**Attachment A
AOS Response to RAI's
Dated 12/24/09**

**Docket 71-9316
TAC No. L24353**

AOS Response to RAIs Dated 12/24/09 (TAC # L24353)

Figure 1. Axisymmetric Head-On Impact Load Distribution

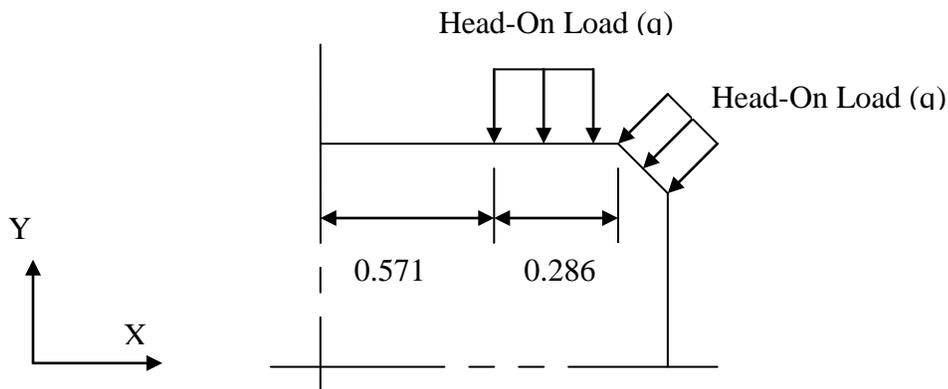
- 2.22 *Provide the numerical values for loads P (total impact force) and Q (pressure load) in the equation used on page No. 2-136 of the application (Section No. 2.7 “Hypothetical Accident Conditions of Transport”) to compute the load intensity in the 2-D cask model.*

Loads applied in the 30 ft accidental drop analyses are listed in the detailed description of the 30-drop analyses given in Paragraph 2.7.1.5.2.1. The head-on impact load distribution is axisymmetric, as shown in Figure 1. The applied traction, q , is given by the total impact force, P , divided by the impacted surface area, A .

$$q = P/A$$

In the Libra program q is entered on a LE -4 records.

Figure 1. Head-On Drop Cask Model

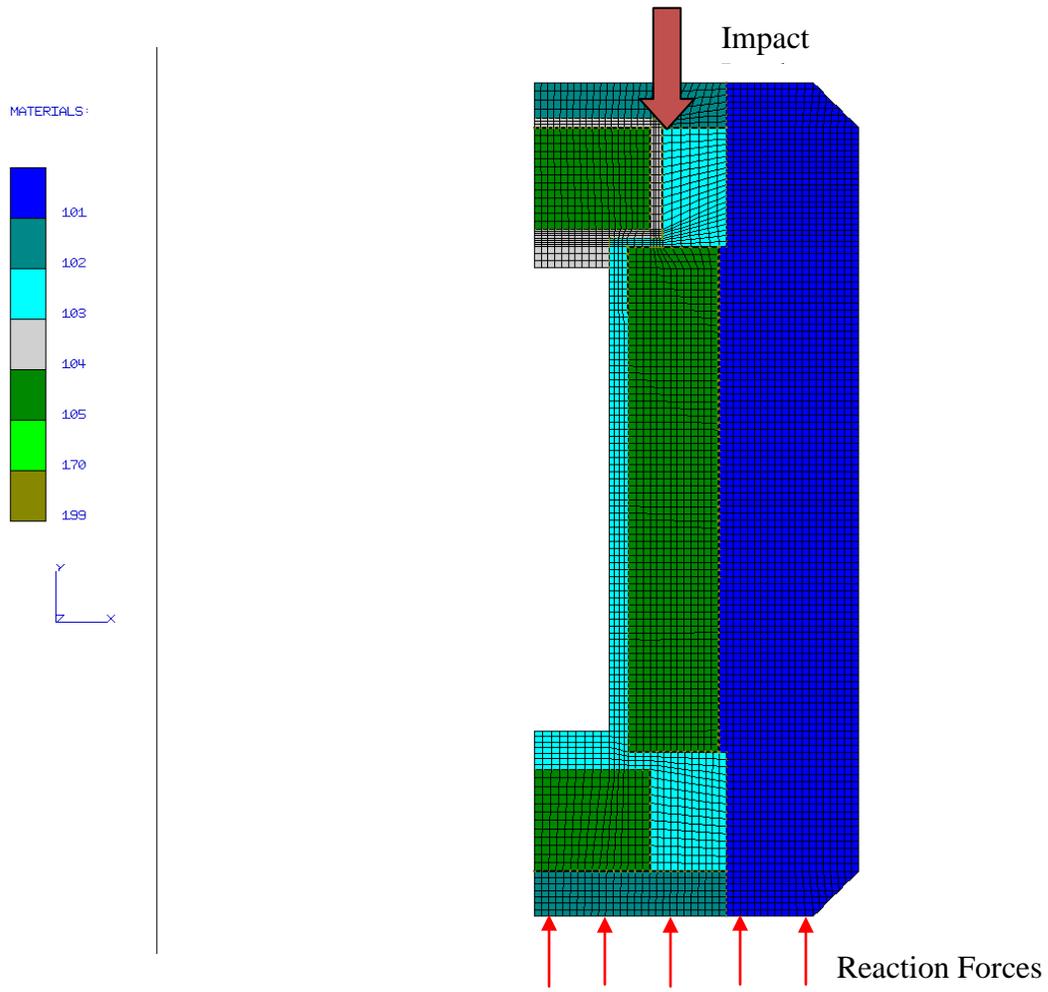
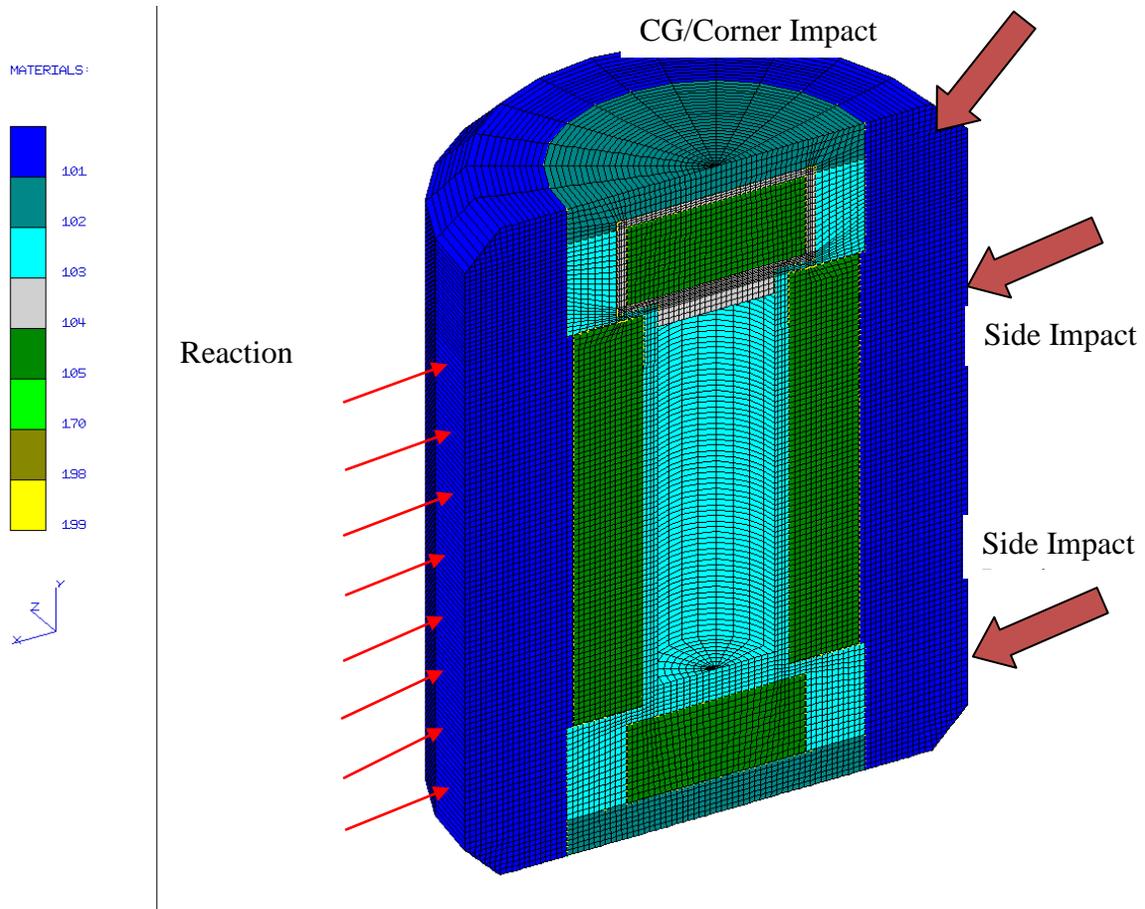
2.23 Describe the form that the inertia body force takes. Section No. 2.7.1.1.2 (page No. 2-136) of the application states that "In addition to the impact load, an opposing inertia body force is applied to the cask. Displacements are fixed along the cask base to account for non-equilibrium of pressure and inertia forces." Provide the magnitude of this force. Show where the fixed nodes are located and list the magnitude(s) of the force(s) at each node.

The following discussion references Table 1 and Table 2, as well as Figure 1 and 2 below. These tables and figures are duplicates of Paragraph 2.7.1.5.2.1 for the model AOS-100, and are presented here for clarity. Impact loads determined in the drop analyses and applied in cask stress analyses are summarized in Tables 1 and 2 given below. Table 1 presents impact loads found in the over-pack drop analyses. Table 2 presents actual loads applied in the cask stress analyses. The actual applied loads, P', in Table 2, should equal or exceed the loads P in Table 1. Explanations of all factors in Table 1 are given in Paragraph 2.7.1.5.2.1. An inertial acceleration, A' in Table 2, is applied in the cask stress analyses in addition to the impact load, P'. The inertial acceleration forces react the impact load and prevent large support loads, while having only a marginal affect on local stress values. The accelerations A' are listed in the second table, and are based on the actual impact load and the weight of the stress model, M, also given in Table 2.

R - total reaction force from FEM cask analysis, $R = P' - A' \cdot M$

The fixed nodes where the reaction forces are located are shown schematically on Figures 1 and 2.

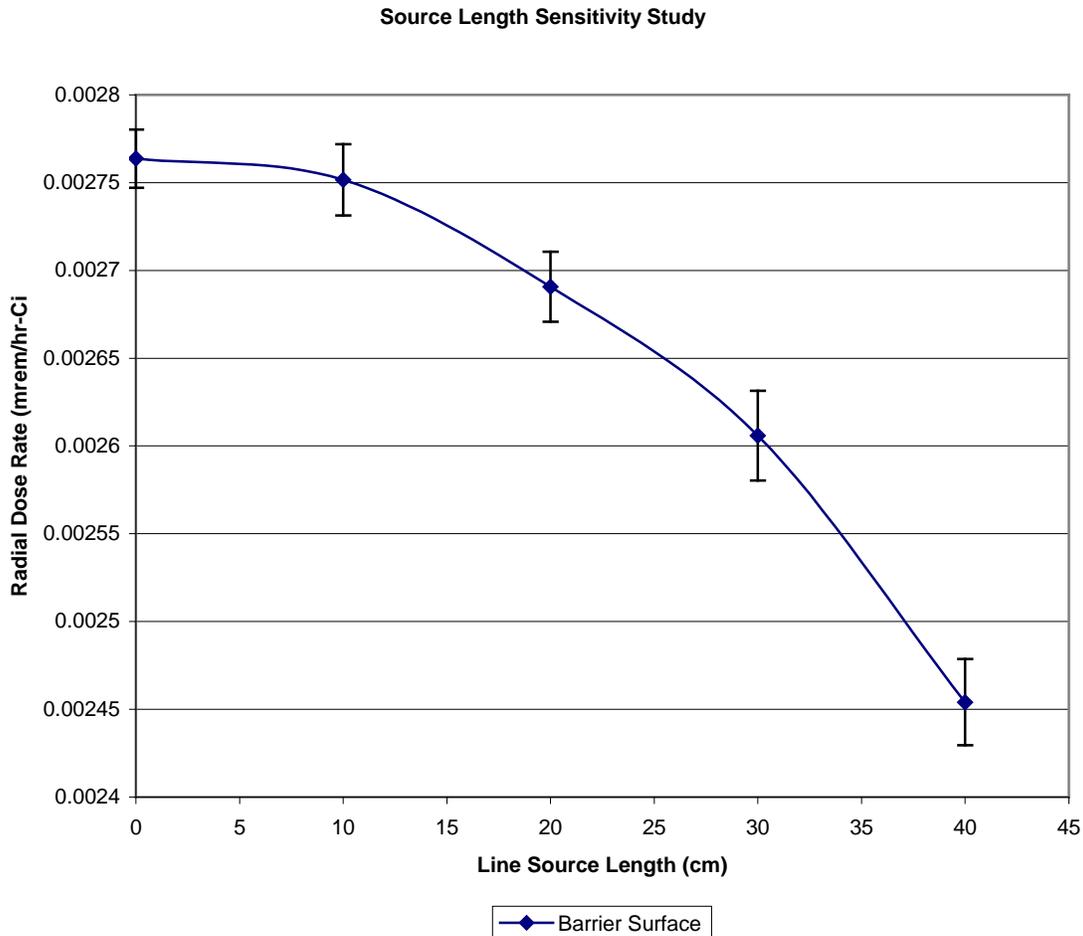
5.3 *Provide additional information to justify the use of the point source approximation.*

In cases where the true source geometry is long enough that it might be better represented by a line source, the error associated with the use of a point source may be large, but it will always be in the conservative direction. This general trend is demonstrated in the supplemental information provided by the review team, including the following websites:
